M.I.L. "ON" DTC P0133 (ONLY)

YEAR(S)	MODEL(S)	ADDITIONAL INFORMATION
2005 – 2006	Matrix	Drive Type(s): 4WD Engine(s): 1ZZ Transmission(s): 4AT VDS(s): LR32E

Under certain driving conditions, some 2005 – 2006 model year Matrix vehicles equipped with 4WD may exhibit a M.I.L. "ON" condition with DTC P0133 (Oxygen Sensor Circuit Slow Response [Bank 1 Sensor 1]). The Engine Control Module (ECM) (SAE term: Powertrain Control Module/PCM) logic has been modified to improve this condition.

Figure 1. Authorized Modifications Label on 2005 Matrix

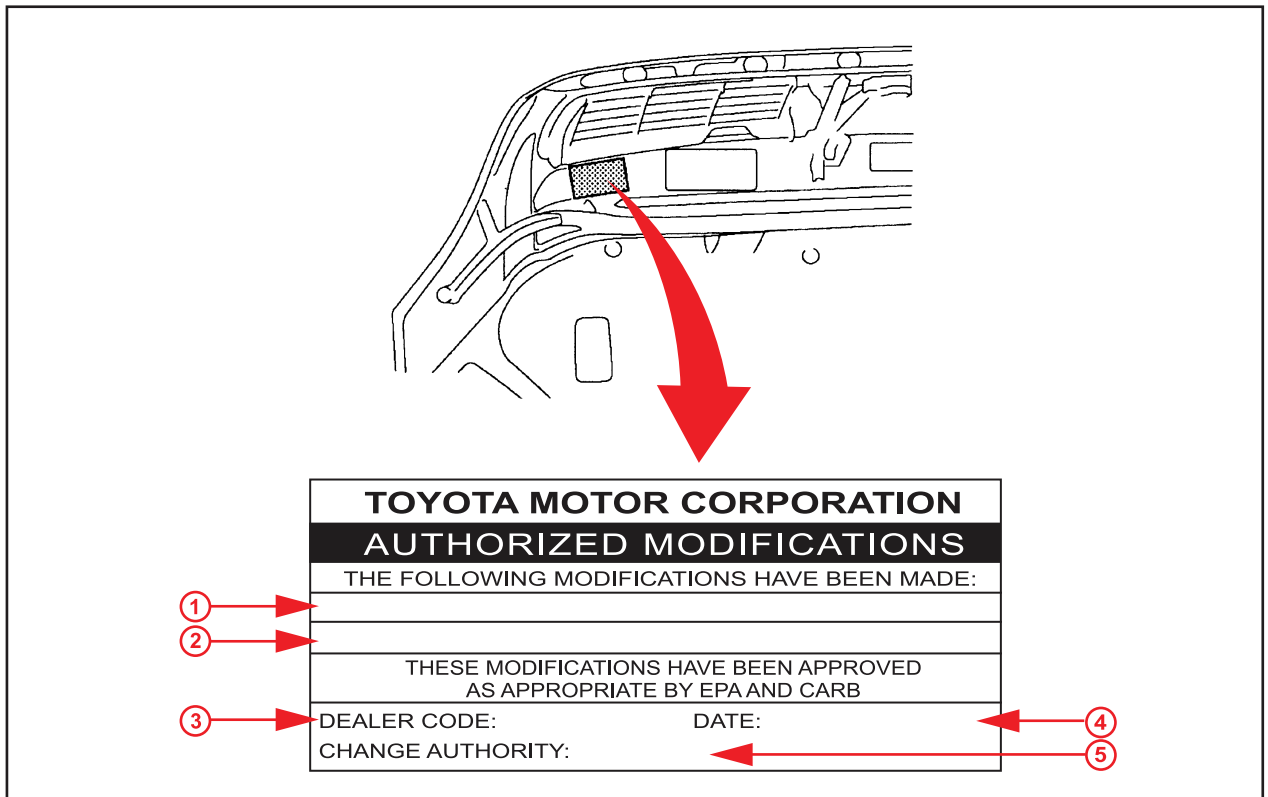
1. Check for the Authorized Modifications Label affixed to the vehicle in the location shown in Figure 1. Confirm if the ECM (PCM) calibration has been updated. If the calibration ID listed is NOT the latest ECM (PCM) calibration — go to step 2.

3. Install the Authorized Modifications Label.
 - A. Using a permanent marker, enter the following information on the label:
 - ECM part number [Refer to the **Parts Information** section for the **CURRENT PART NUMBER**]
 - Calibration ID(s) [Refer to the **Calibration Identification Chart** for the **NEW CALIBRATION ID**]
 - Dealer Code
 - Repair Date
 - Change Authority [**This TSB number**]
 - B. Affix the Authorized Modifications Label to the vehicle at the location shown in Figure 1. The Authorized Modifications Label is available through the MDC, P/N 00451-00001-LBL.
4. Start the engine and warm it up to normal operating temperature before test driving.
5. Test drive the vehicle to confirm proper vehicle operation.
6. Calibration update is complete.
